MONROE COUNTY PLAN COMMISSION ADMINISTRATIVE MEETING

**May 5, 2016
6:00 pm**

PLANNER Tammy Behrman
CASE NUMBER 1601-SPP-01, Holland Fields Major Subdivision Preliminary Plat and Road Width Waiver, Sidewalk Waiver and Street Tree Waiver
OWNER Gardner, Michael D; Gardner, Mark A; & Gardner, Barry T
PETITIONER Hybrid Development Group c/o Smith Brehob
ADDRESS 790 E Holland Drive
REQUEST Major Subdivision Preliminary Plat to subdivide 1 parcel into 55 parcels
ZONE RE3.5/PRO6
ACRES 23.24 acres +/-
TOWNSHIP Perry
SECTION 21
COMP. PLAN
DESIGNATION Mixed Residential

JOB NUMBER
5233
SHEET
3 OF 19
DATE
03/03/16

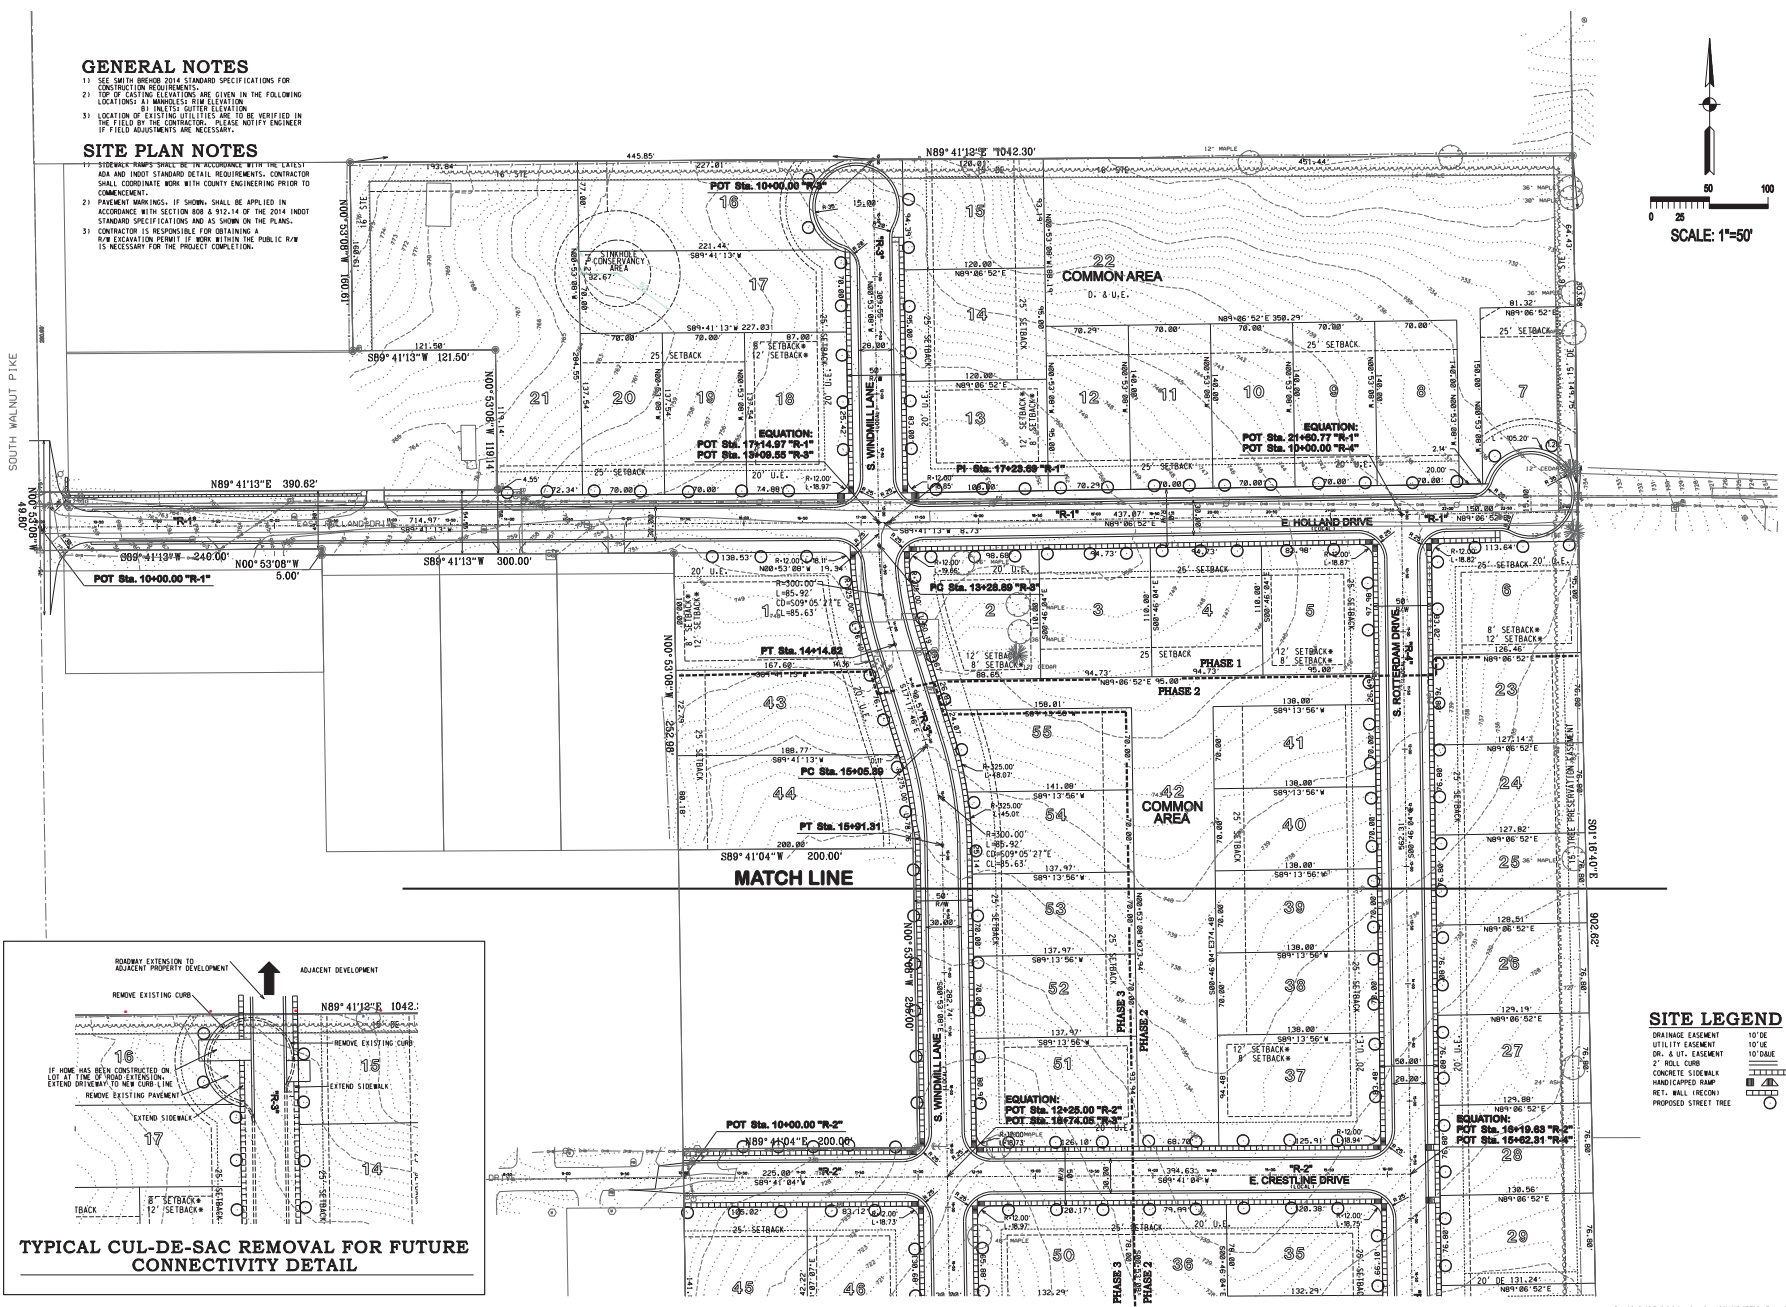
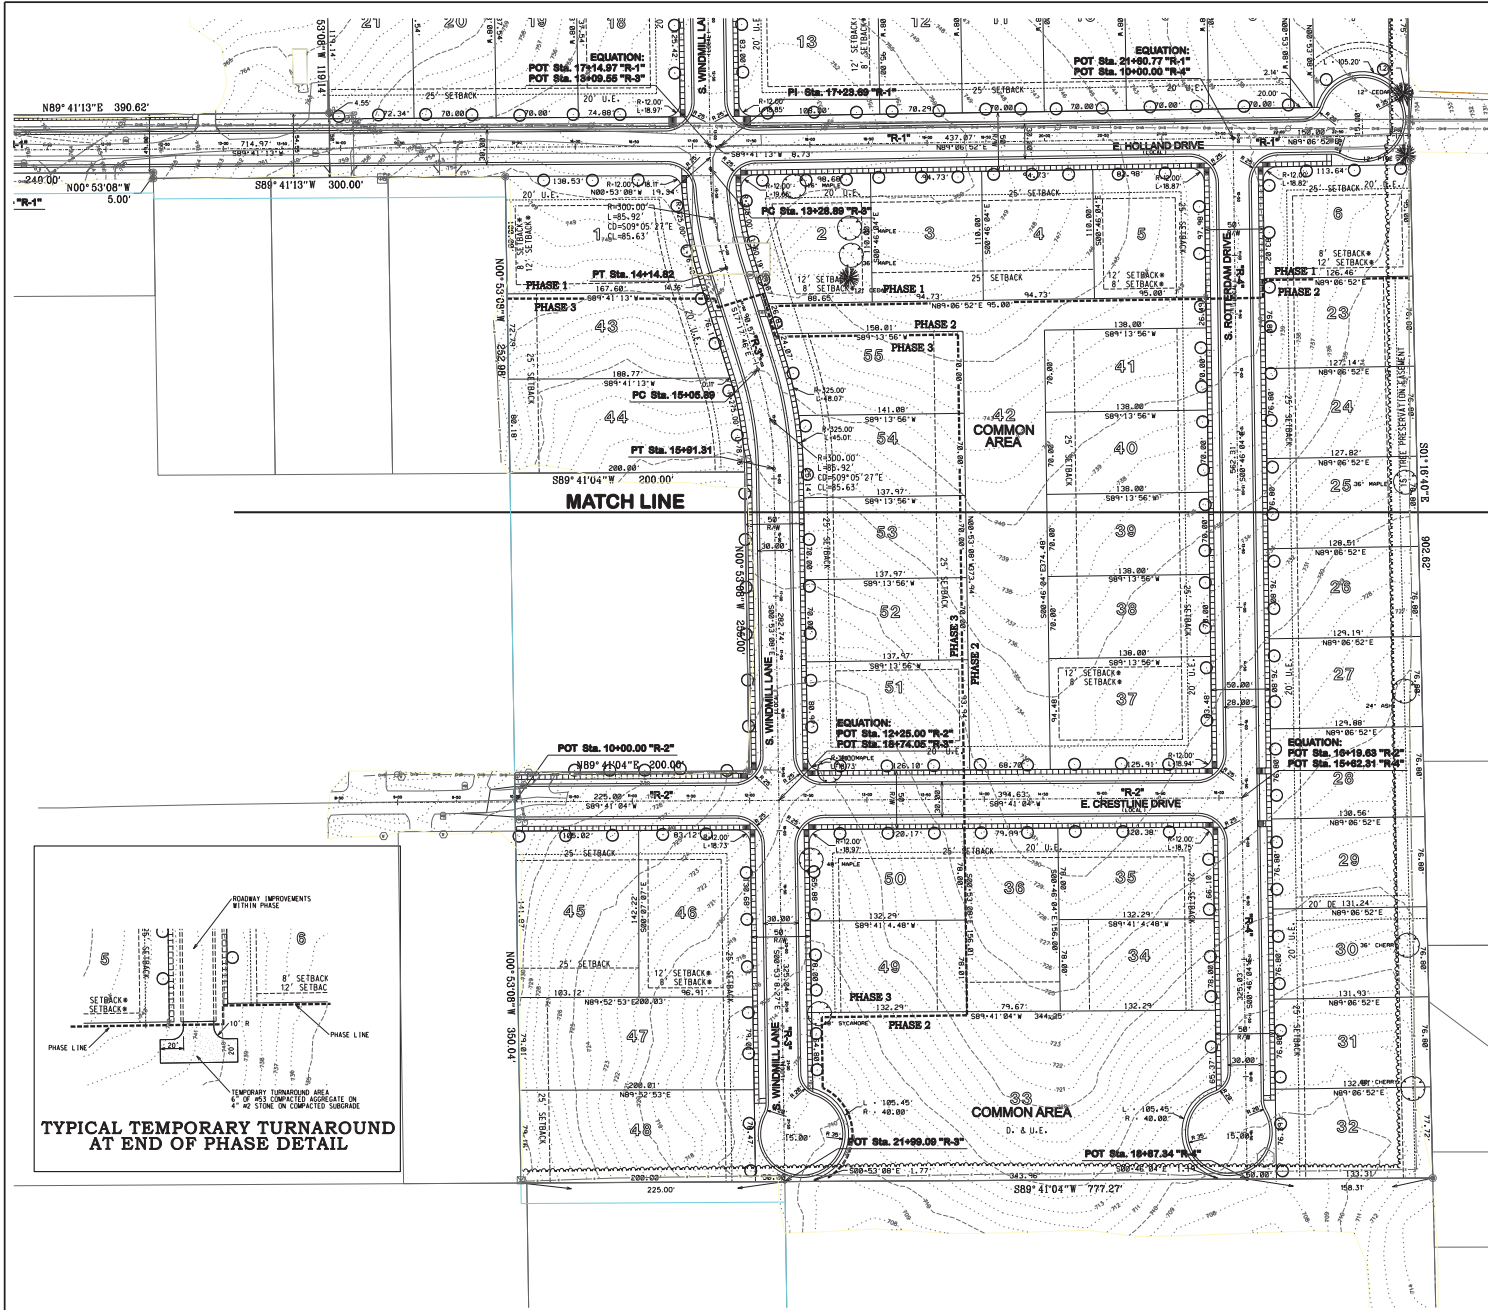
1. Waivers
 - a. 761-7 (c) (4) watershed area for bioretention shall not exceed two acres (based on experience this does not work in single family residential areas because property owners don't like small practices scattered throughout the development.)

- b. 761-7 (c) (1) (b) riparian buffers zones for all waterways greater than 10 acres (The waterway within this project is a broad swale in an open field. It contains no riparian habitat and does not hold storage necessary for mitigation of flood peaks.)

- c. 761-5 (b) emergency spillway (This waiver allows for greater volume in the southern detention basin.)
 - d. AD26 – underdrain for bioretention (This waiver allows for greater volume in the southern detention basin.)

2. A plan showing re-use of existing topsoil on the site will be needed.
3. Permanent monuments describing all of the open areas shall be installed.
4. Drainage easements (minimum 20' wide) for all swales and other stormwater infrastructure are needed as specified in Chapter 761.

5. One inch of storage is needed for the new impervious surface draining to Walnut Street Pike and for the new impervious surface on Windmill and Hague Streets south of the southernmost street inlets.

6. A landscaping plan is needed for the detention basins utilizing trees, shrubs, and turf grass.
7. Detention basin outlets may need to be revised by adding another orifice in the riser pipes.

10. At the intersection of Holland Drive and Walnut Pike, wrap curb and gutter around radius and tapers. Transition curb and gutter height to 0” at the end of the curb and gutter.
11. A vertical curve design speed of 30 mph is recommended for all streets in this subdivision. The following vertical curves do not meet the 30 mph vertical curve design requirements on Holland Drive, Line R-1, Sta. 14+59.67 (25 mph)
12. Stop condition should be used at the following locations:
 - a. Crestline Drive stop at Windmill Lane
 - b. Windmill Lane stop at Holland Drive
 - c. Hague Drive stop at Holland Drive
 - d. Crestline Drive stop at Hague Drive
13. Signs are to be placed on the cul-de-sacs to discourage parking in the emergency turnaround areas.
14. Incorporate monuments that clearly designate common area boundaries.
